Project: Fillmore High School Modernization

Project Number: WGD 20624 DSA# 03-121233

Addendum 03 – Mechanical Unit Replacement

Date: September 8, 2023

E101 – Library Reflected Ceiling/ Floor Plan Bldg. 8

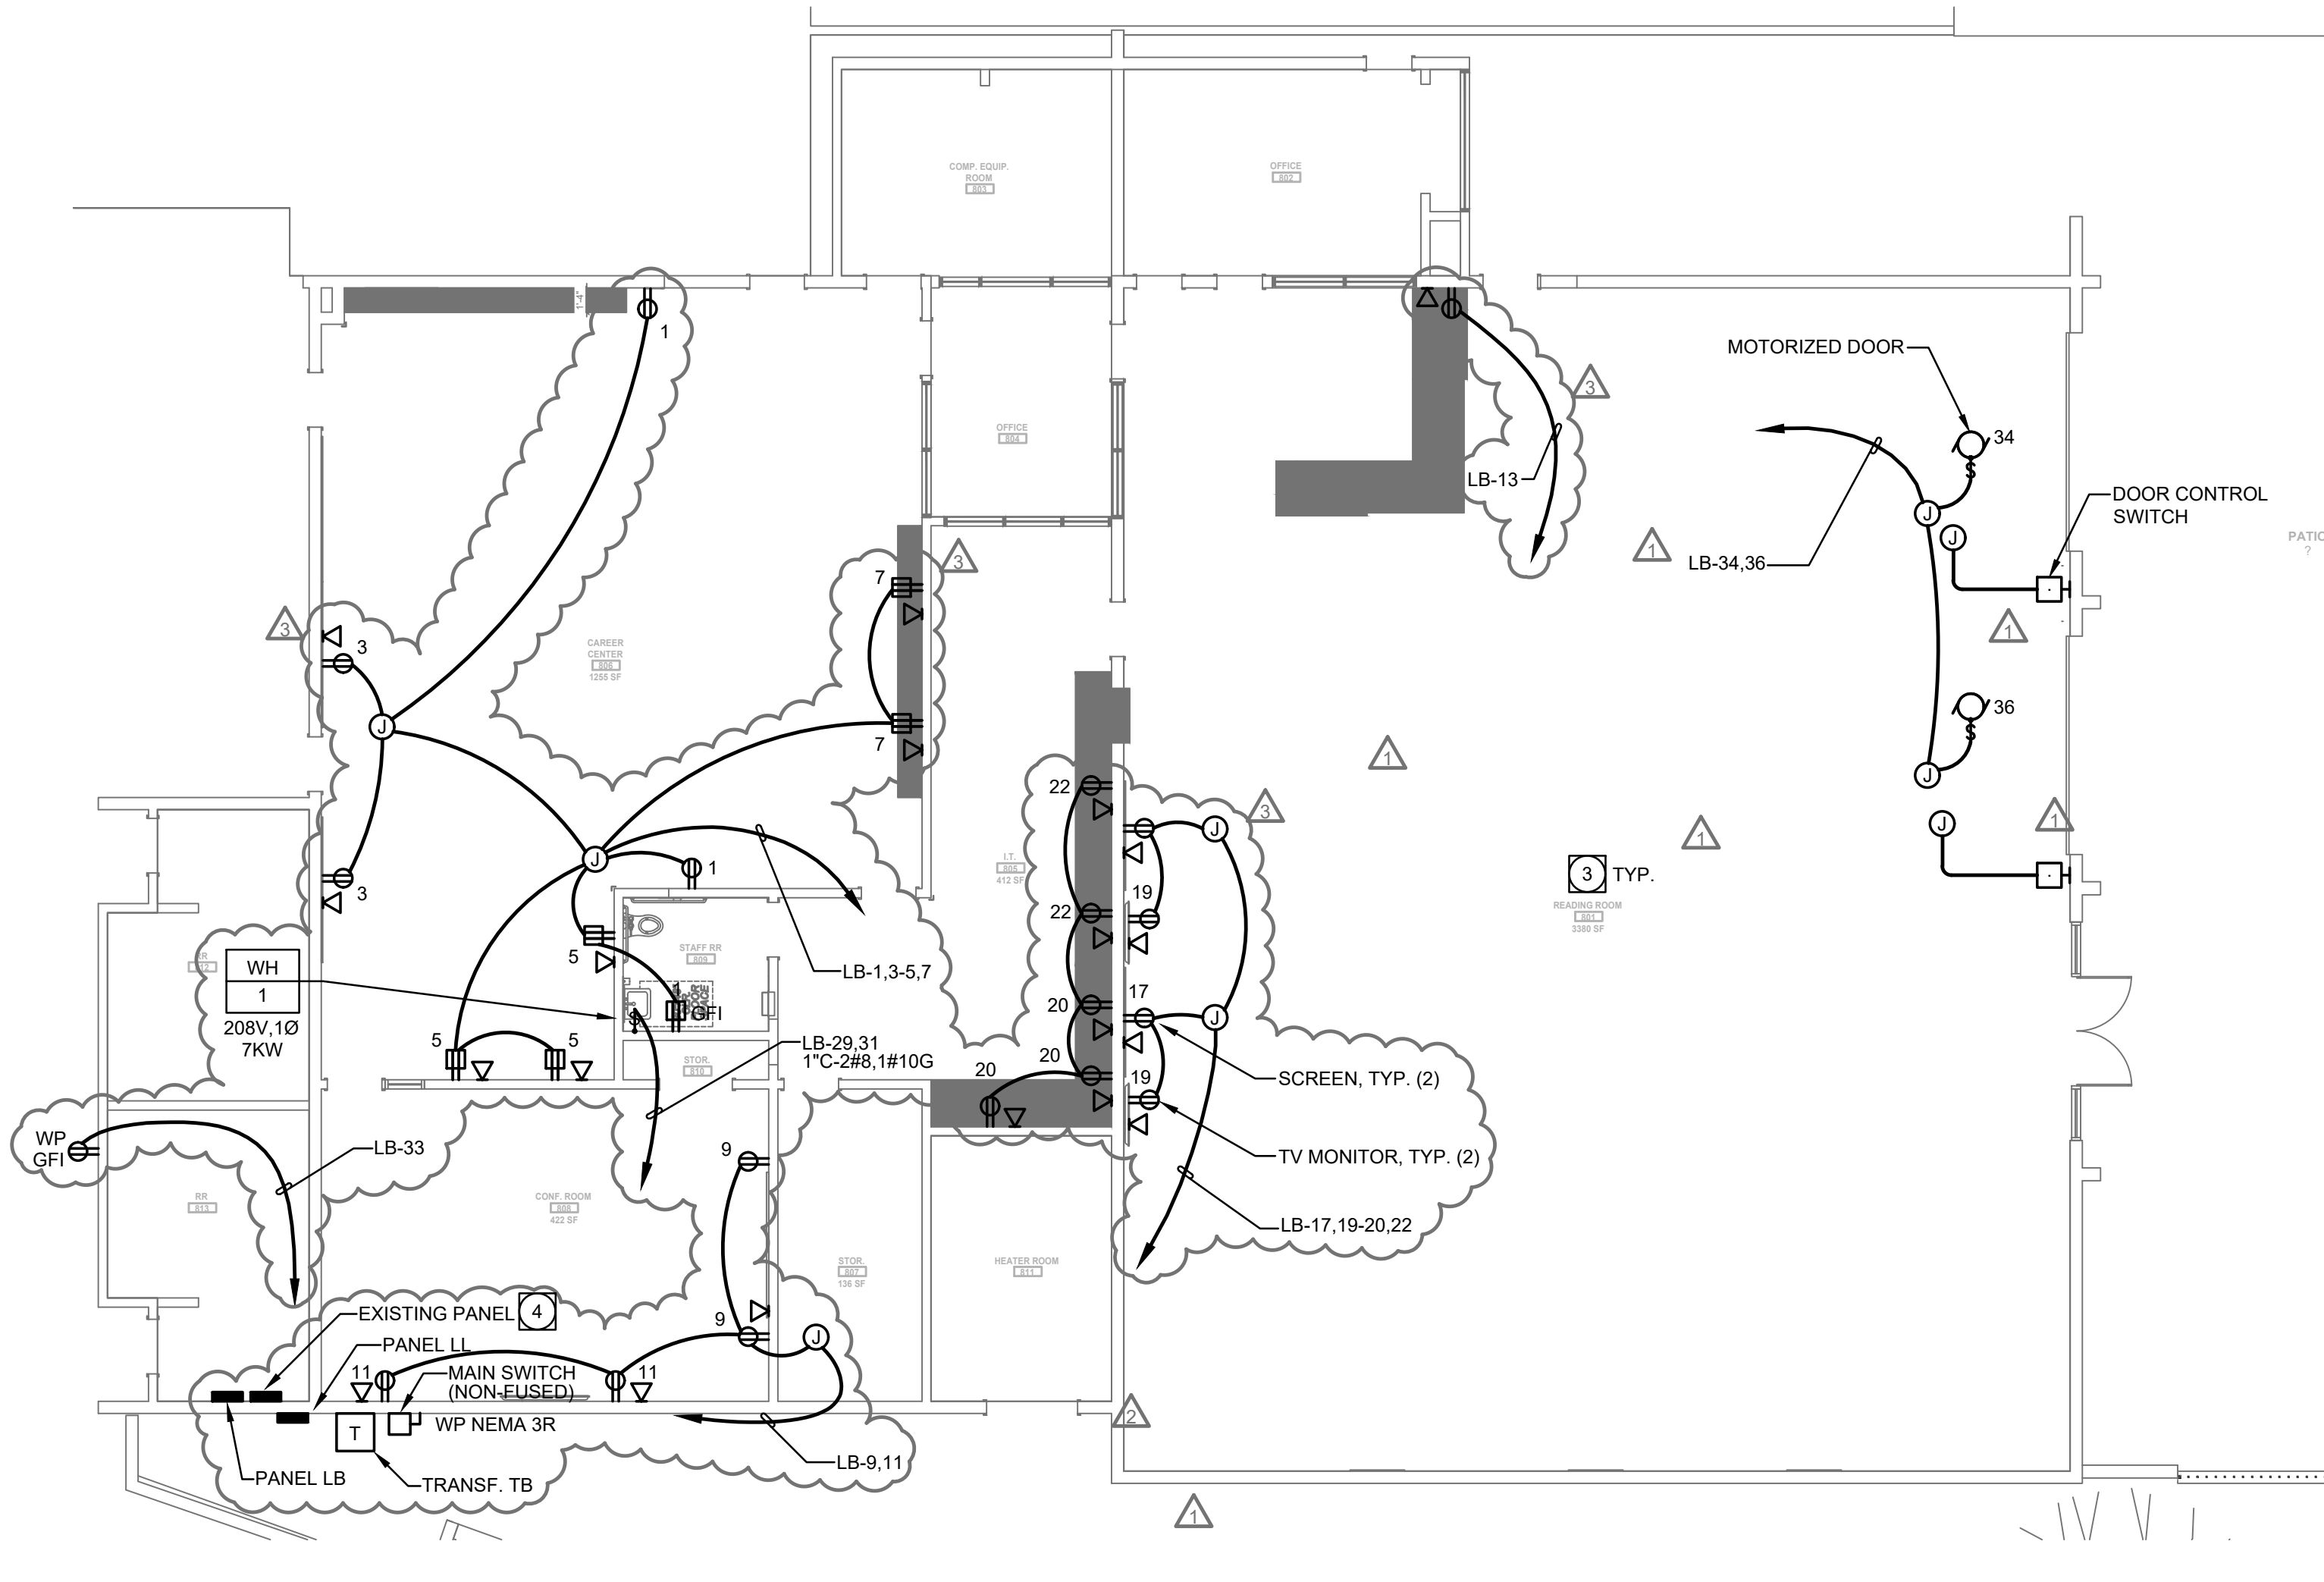
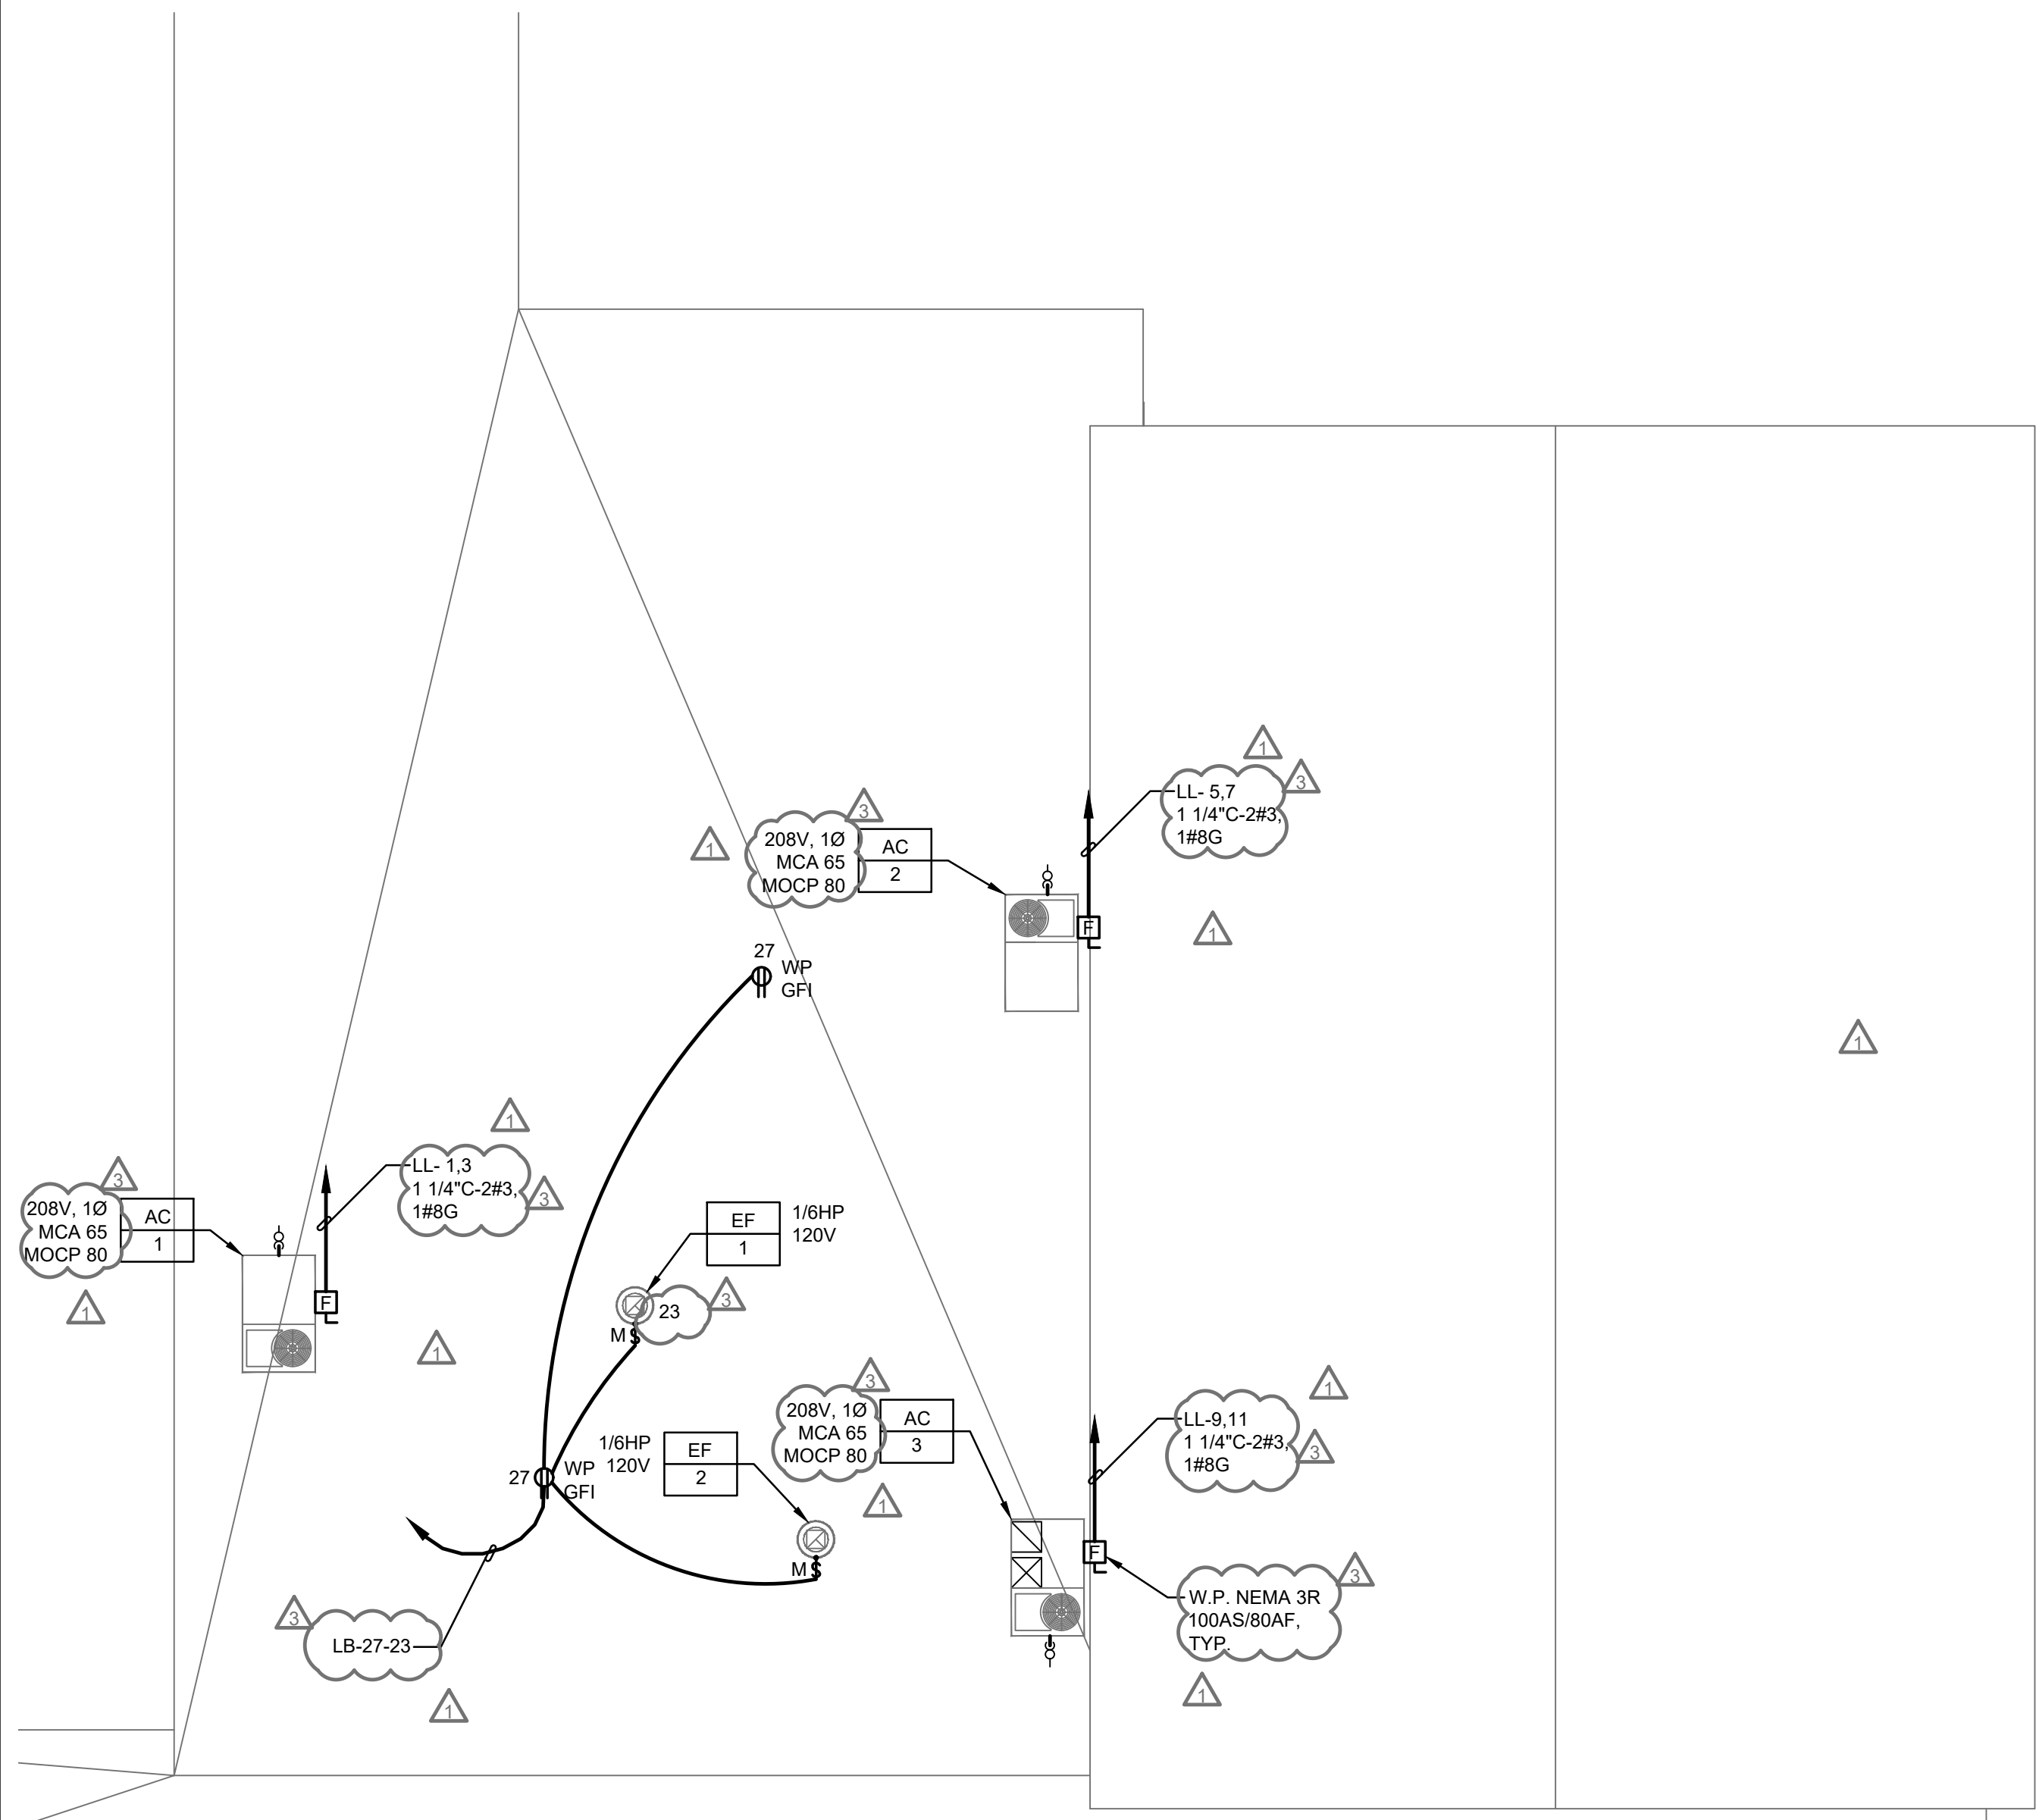
- a. Plan 1-Added circuitry to the building interior connecting new load.
- b. Plan 1-Noted to replace existing panel with panel LB.
- c. Plan 2- Revised power connection for AC-1, 2, &3.
- d. Eliminated panel schedule H8 and added panel schedule LL.
- e. Added Plan Notes 4.
